UNITED STATES ENVIRONMENTAL PROTECTION AGENCY
NEW ENGLAND - REGION I
1 CONGRESS STREET, SUITE 1100 (HBT)
BOSTON, MASSACHUSETTS 02114-2023

N62578.AR.002241
NCBC DAVISVILLE
5090.3a

October 22, 2007

Re: Interim Groundwater Sampling Event 05-April 2007 Results Report for Site 03: Construction Equipment Department, at the former Davisville Naval Construction Battalion Center, North Kingstown, RI dated September 2007

Figure 1. Deep overburden ground water flow direction.

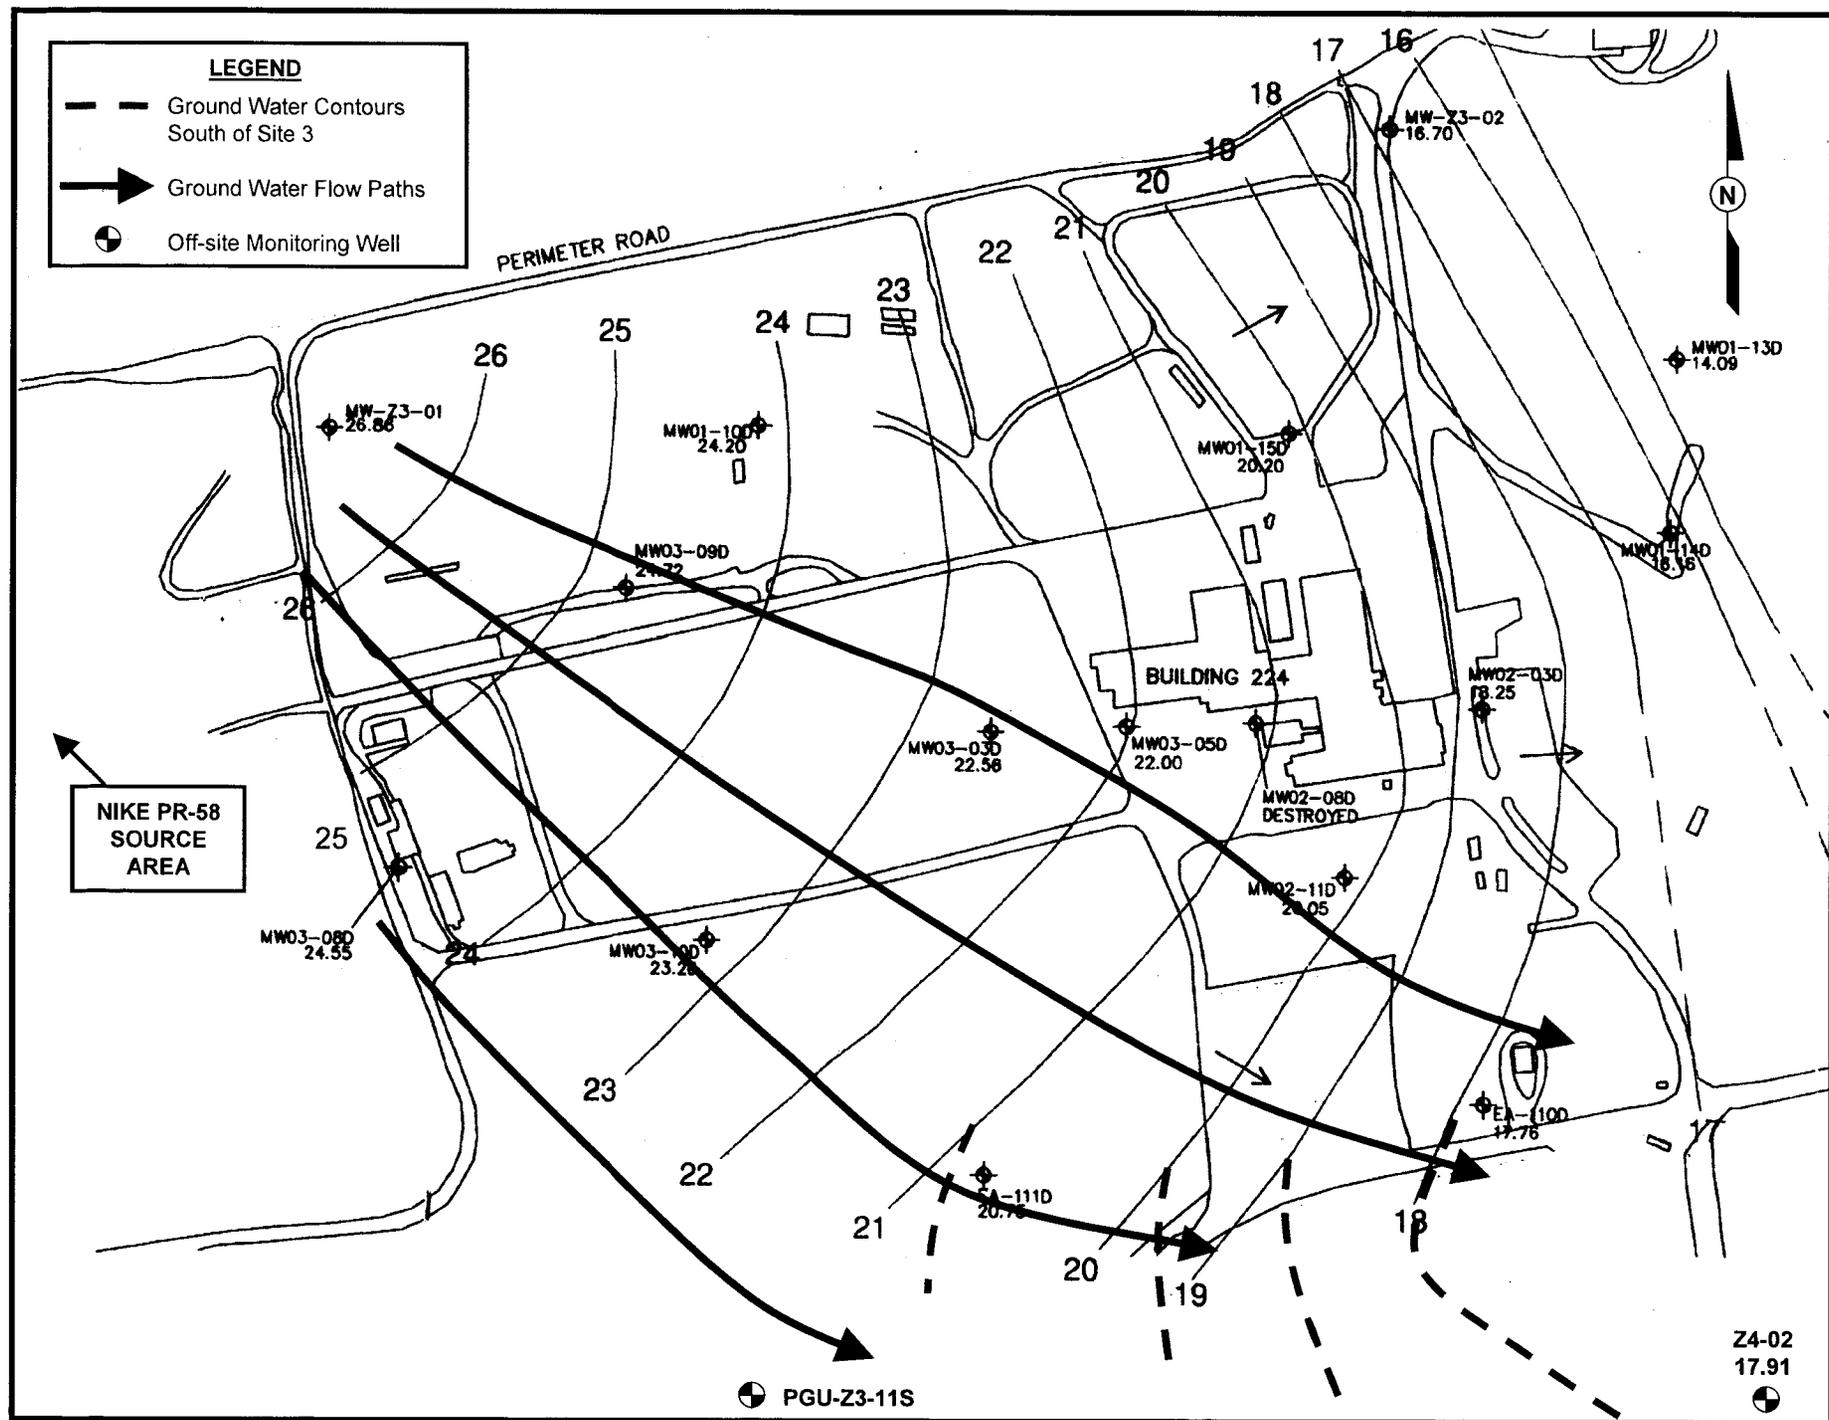
Further, while the Navy Figure 3A for the deep overburden did not include the ground water elevation from MW Z4-02, the ground water elevation for that deep overburden well measured during the same synoptic ground water elevation measurement round clearly shows that the deep ground water flow direction follows an inflection in the ground water flow patterns. This axis of ground water flow is oriented into the Site 16 area. Therefore, CVOC released at the former Nike PR-58 site, the western boundary of Site 03, or the northwest corner of Site 03 (possibly the vicinity of EA-104 just west of the Site 03 boundary) is likely to migrate to the location of Site 16 following the ground water flow lines from those locations. The ground water flow path from these locations extends over a wide segment of the southeast boundary of Site 03 as shown on the attached Figure 1.

Comment 1: *Page 1-3, Section 1.3, 2nd Paragraph:* The statements in this paragraph are incorrect and misleading. Specifically, the Navy judges the CVOC source to be on the former Nike PR-58 site. While a source does exist at that location, it is clearly not the only source at Site 03 or just off of the Site 03 boundaries. In particular, it is not clear that a source does not exist at the northwest corner of Site 03 or just across the boundary at the location of EA-104D/R. Also, the statement that studies on the Nike PR-58 site shows “the main plume moving east toward the adjacent Navy property (designated as Parcel 7). A branch of the plume has been determined to extend to the north, beyond the Navy property line, towards private residences identified as having private wells” is not correct. The Navy has only to look at its own ground water contours for the Site 03 deep overburden and bedrock ground water to see that the primary direction of ground water flow is to the southeast from the former Nike PR-58 site and the western and northwestern areas of Site 03. The Navy Figures 3A and 3B with ground water flow paths superimposed are attached as Figures 1 and 2 of this technical document review.

Site 03 area. As shown on Figures 1 and 2 attached, groundwater flow from the former Nike PR-58 site source area and the western boundary of Site 03 migrates in a southeastern direction. Monitoring well distribution at Site 03 is weighted to the north and northeast in the Site 03 area.

Comment 5: *Page 2-1, Section 2.1, Last Sentence:* The statement “Groundwater in both the deep overburden and bedrock aquifers is interpreted to generally flow to the east, towards Allen Harbor and Narragansett Bay” is not supported. Inspection of Figures 3A and 3B of this IGWSE report clearly show the primary direction of groundwater flow to the southeast as shown on the attached Figures 1 and 2.

Comment 8: *Figure 3A:* This figure clearly shows that the predominant direction of groundwater flow from the western boundary of Site 03 and the former Nike PR-58 Site source area is to the southeast. This is in conflict with the Navy statements in the text of the IGWSE Report 5 that flow is generally to the east. The Navy description of groundwater flow directions should be amended to reflect the data presented on this figure. Further, this data supports the USEPA interpretation that the direction of groundwater flow from Site 03 and the former Nike PR-58 site is channeled into the Site 16 area, as shown on the attached Figure 1, which includes the groundwater elevation for monitoring well MW Z4-02 that was taken during this synoptic groundwater elevation measurement event. Figure 1 also shows the approximate location for PGU-Z3-11S which had a detection of over 50 µg/L of CVOC during the pore water sampling event conducted at this time. Therefore, in addition to the in-place wells being inadequate in number and yielding data that may not be representative of groundwater at those locations,

Figure 2. Bedrock ground water flow direction.

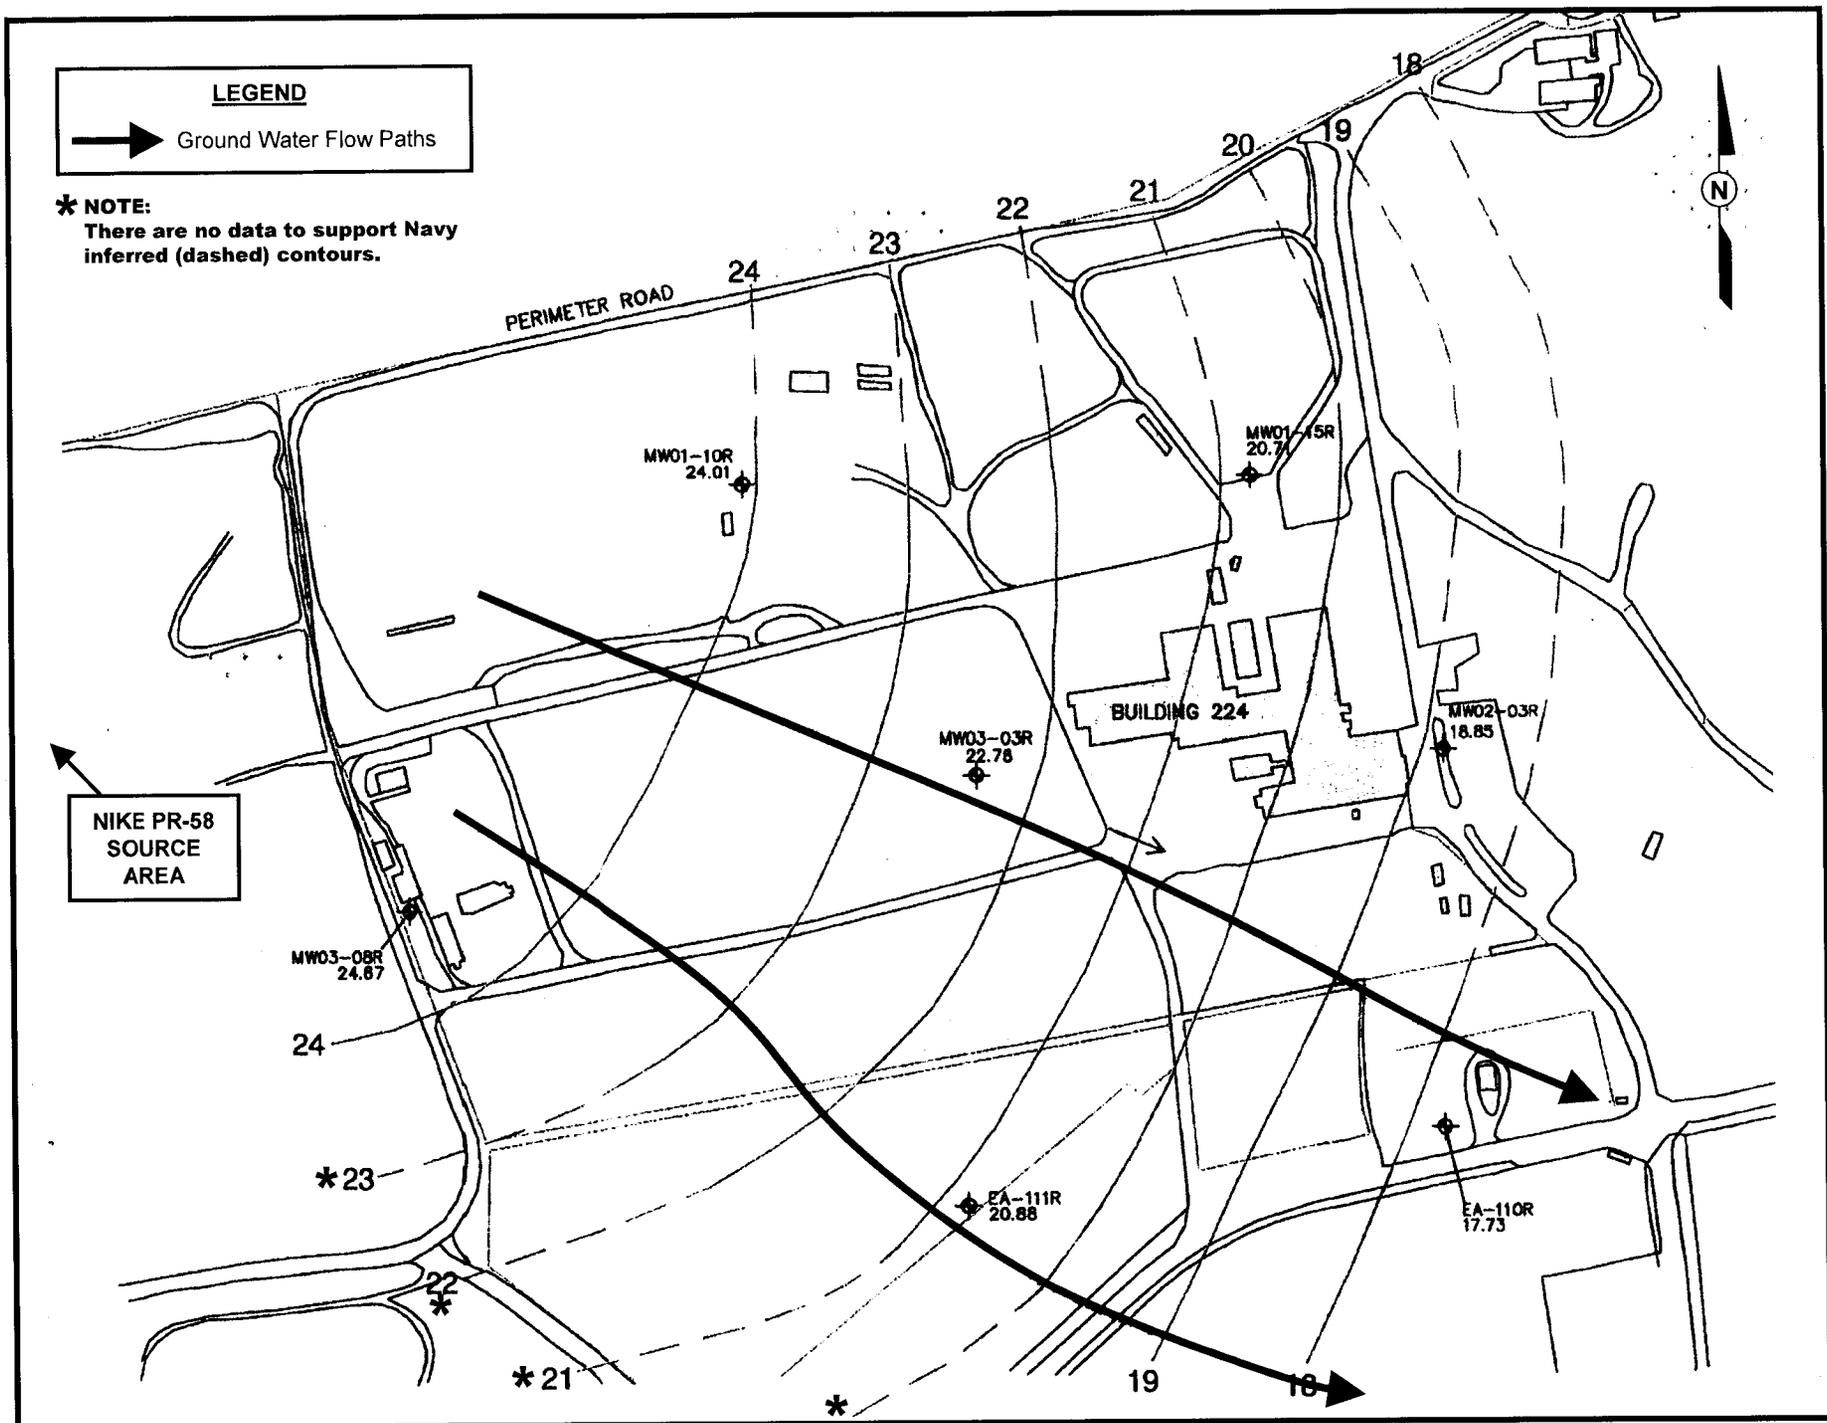
Comment 9: Figure 3B: The groundwater flow direction in the bedrock is clearly to the southeast as shown by the data presented on this figure. This is in conflict with the Navy statements in the text of this report that flow is generally to the east toward Allen Harbor and Narragansett Bay. The data presented shows that the predominant direction of groundwater flow in the bedrock is to the southeast as shown on Figure 2. The text of the Navy report should be amended to reflect the data that shows the predominant direction of groundwater flow is to the southeast toward Site 16. Additionally, this figure should be amended to remove the dashed groundwater contours to the southwest. There is no data, i.e. bedrock wells, to support the sweeping turn to the south of the dashed contours to the southwest of EA-111R.
